RE: Major Accident Hazard Assessment - Request for further information

Please see below our response to the request from the Health and Safety Authority (HSA) of 4 October 2006 for further information on the Major Accident Hazard Assessment for the Dublin Waste to Energy facility.

PLAN VIEW NH₄OH TANK

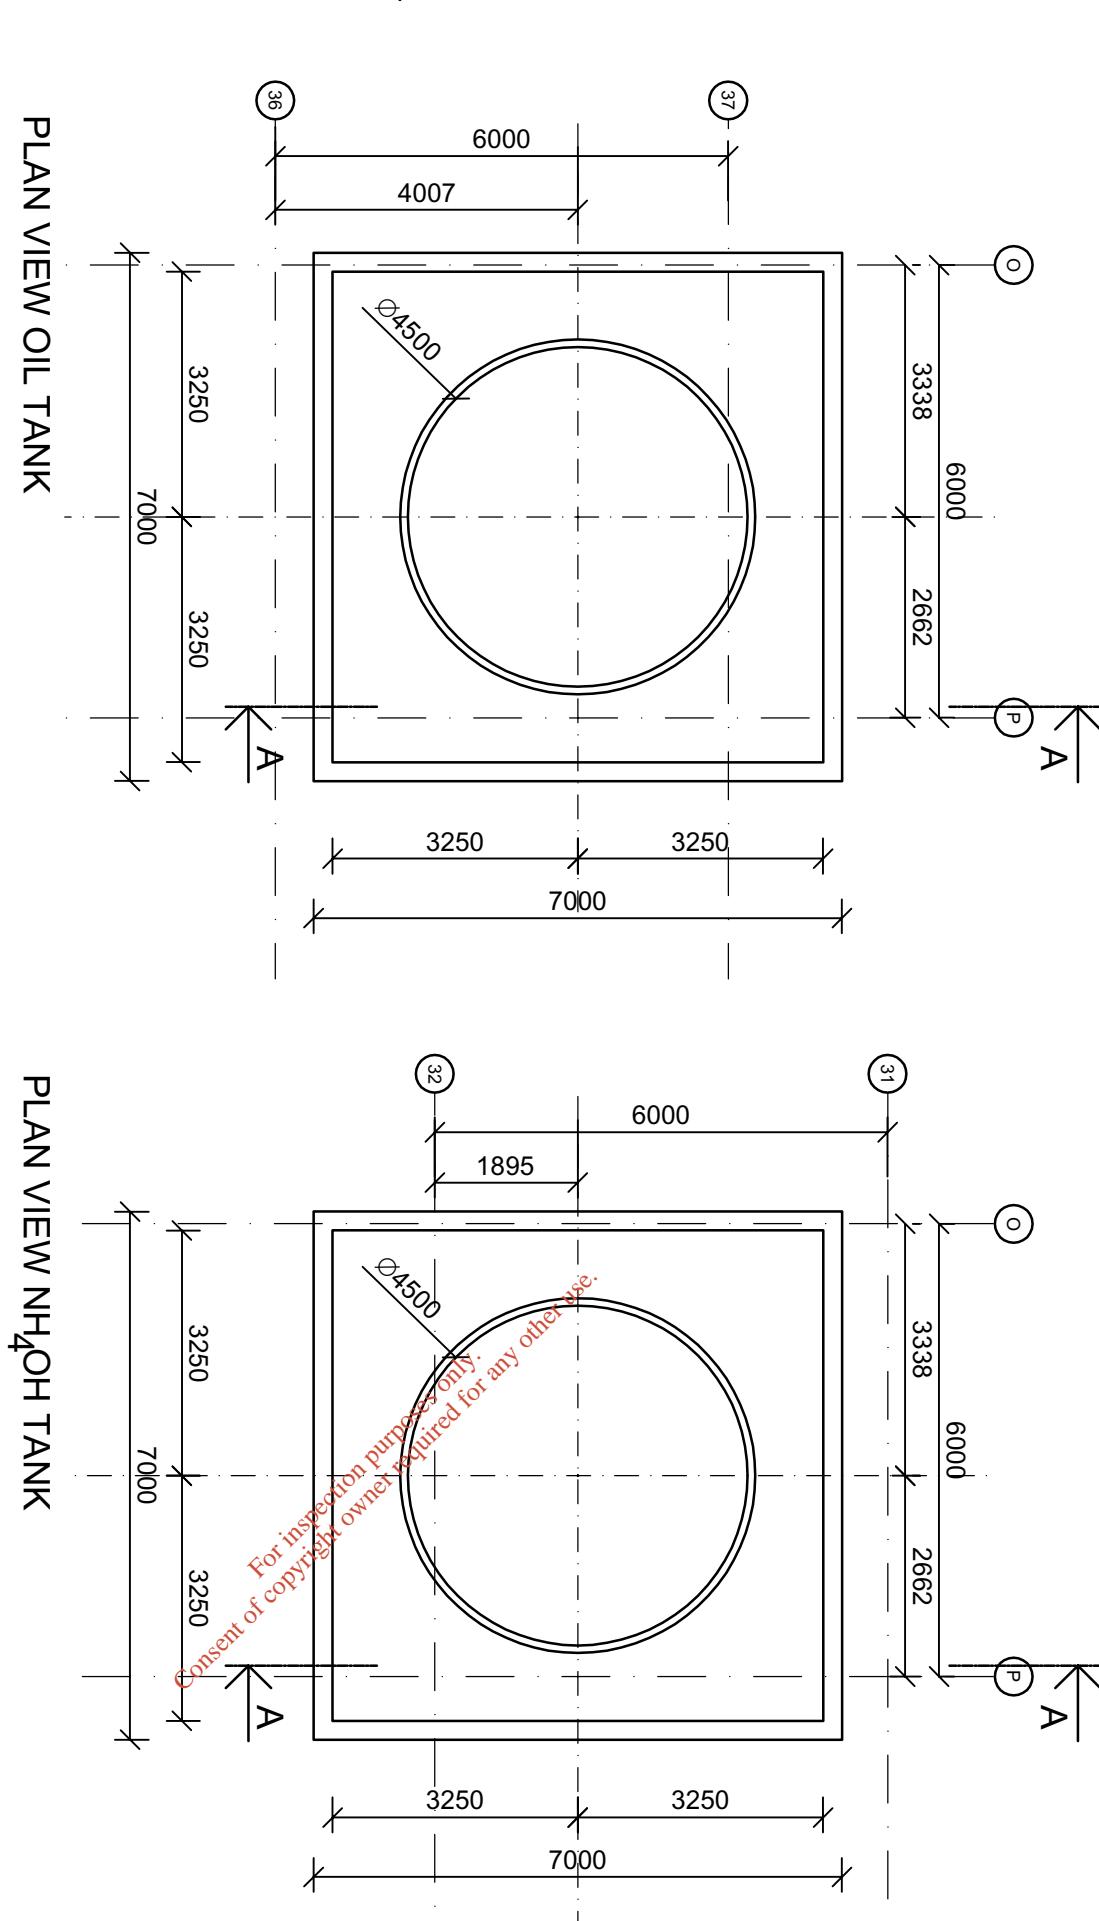
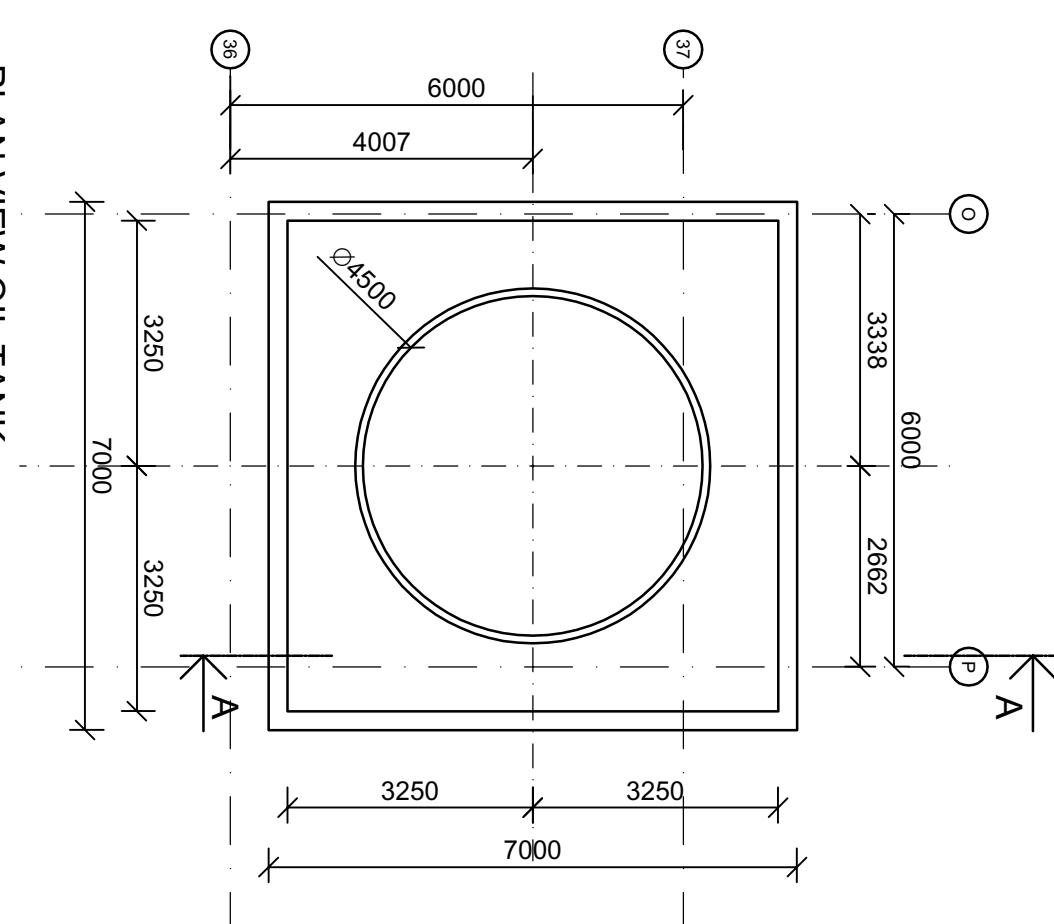
- 14. Section 6.1.1 – provide more details on bund and tank dimensions, and on the building drainage system.**
 Please find details on bund and tank dimensions for the diesel oil storage tank and the NH₄OH storage tank on the enclosed sketch 3.
 Details of the building drainage system can be found on the enclosed drawing UZT/BE040a, Drainage and Sewage Plan and drawing GD/MQ001d, Water Flow Diagram. Please also find enclosed Sections 5.5.18 to 5.5.36 of the EIS with a description of the drainage and wastewater systems of the Dublin Waste to Energy project.
